CITY OF NAPOLEON - BUILDING DEPARTMENT

Additional Information: Replace existing concrete porch, walk, steps and planter with treated wood. See plan correction sheet.

RESIDENTIAL PLAN CORRECTION SHEET

ADDENDUM TO Permit No. 01400-(1)
 Owner HAL GRIFFIN
 Contractor MARTY HOBREFF
 Location LAKEVIEW DR

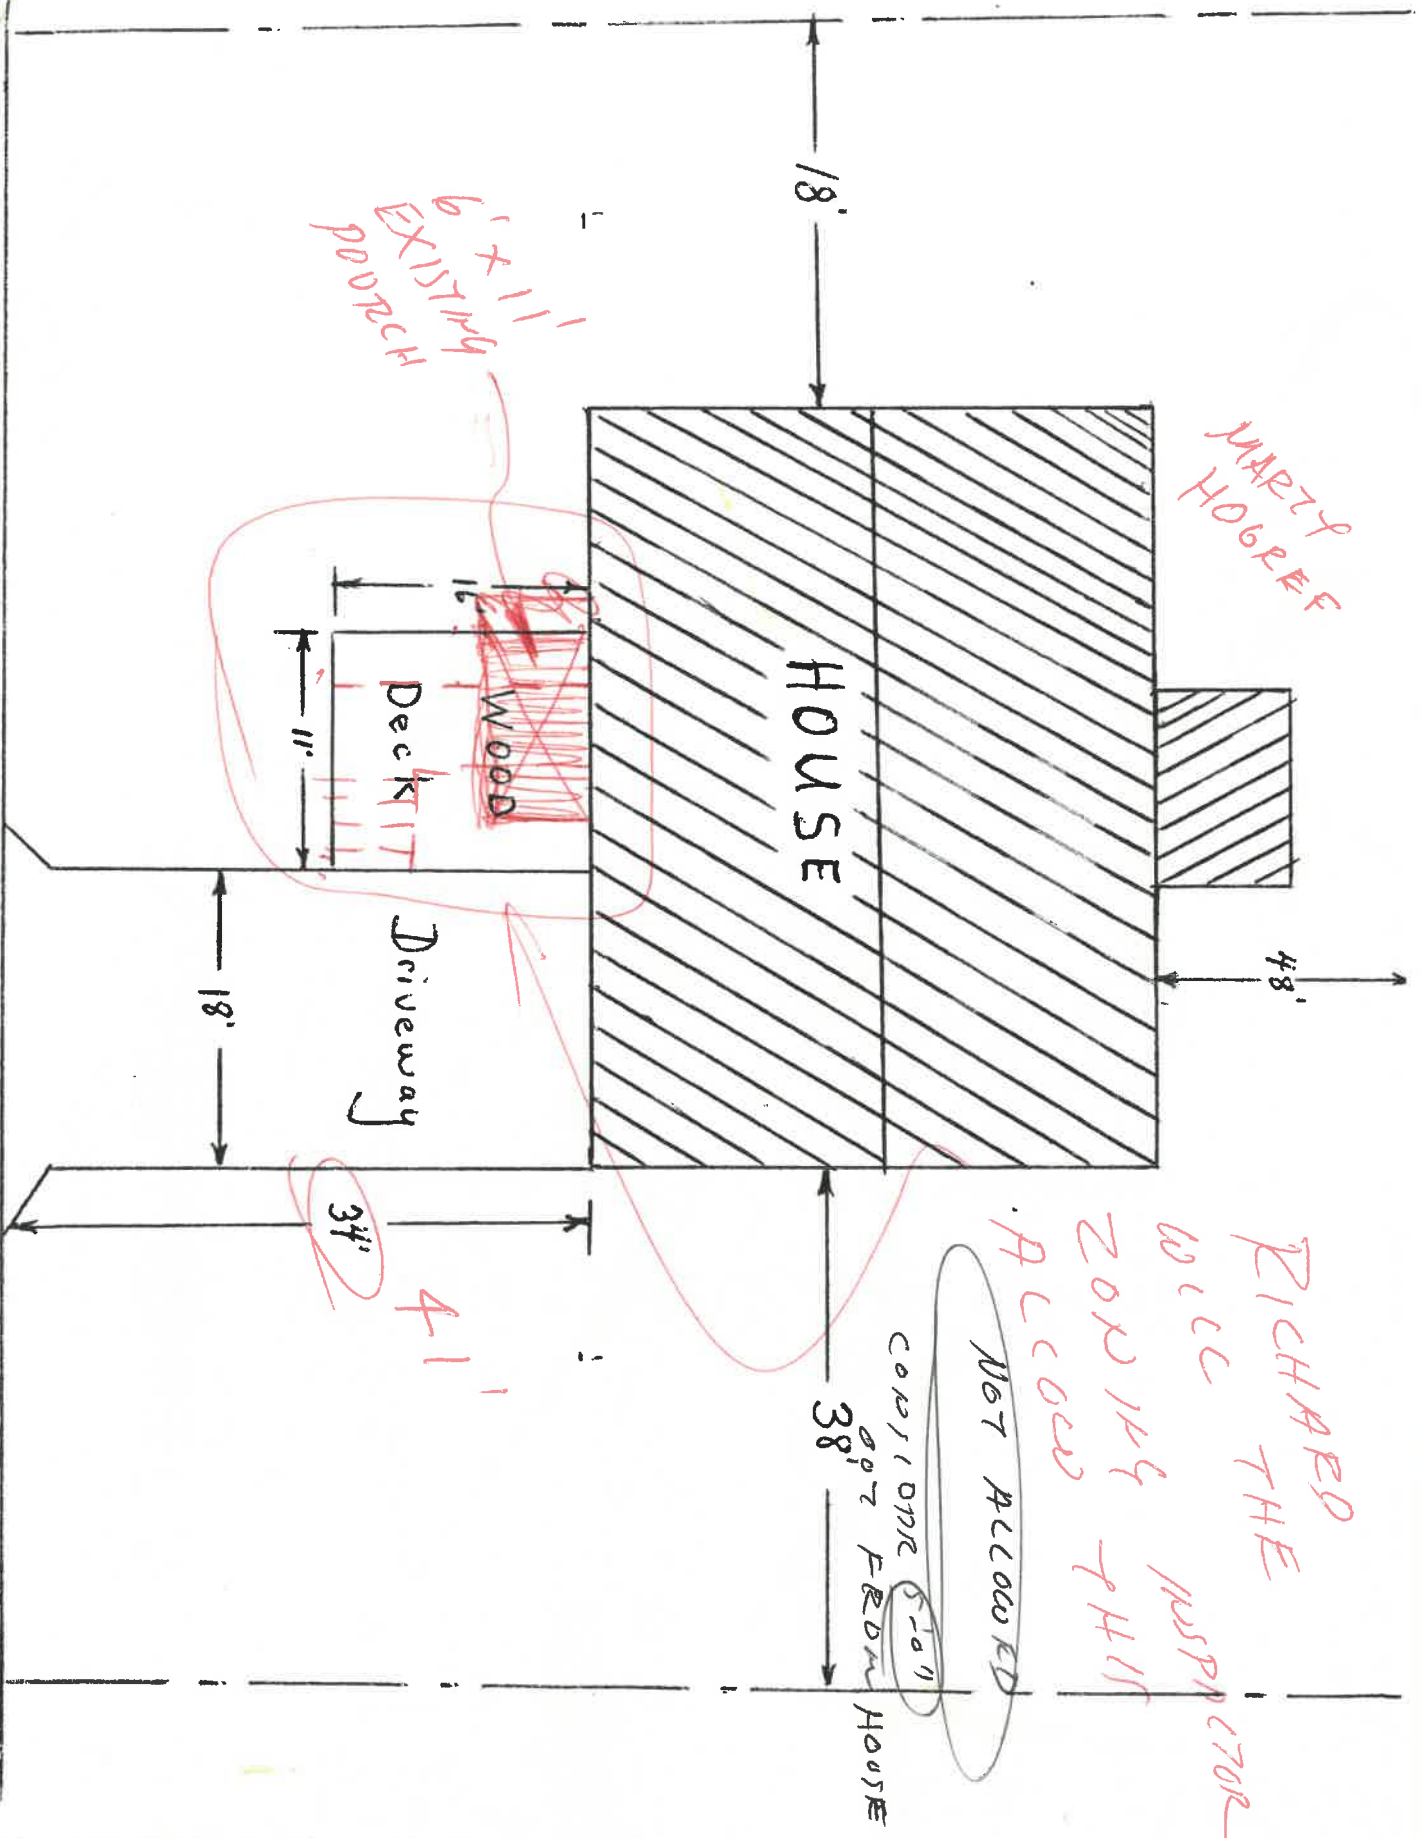
Additional Corrections. THE PERMIT IS ISSUED TO COVER THE CONSTRUCTION OF A 11'-6" X 16' PORTION OF THE DECK LOCATED OVER THE WALK, PLANTER + STEPS WHICH WERE REMOVED. THE RAILINGS 4" E.W. X 10' D.S. CAN BE CONSTRUCTED IF THE VARIANCE IS GRANTED

THIS SECTION REQUIRES A VARIANCE

THIS PORTION COVERED BY PERMIT NO 01460

CORPORATE FROM HOUSE

NOT ALLOWED
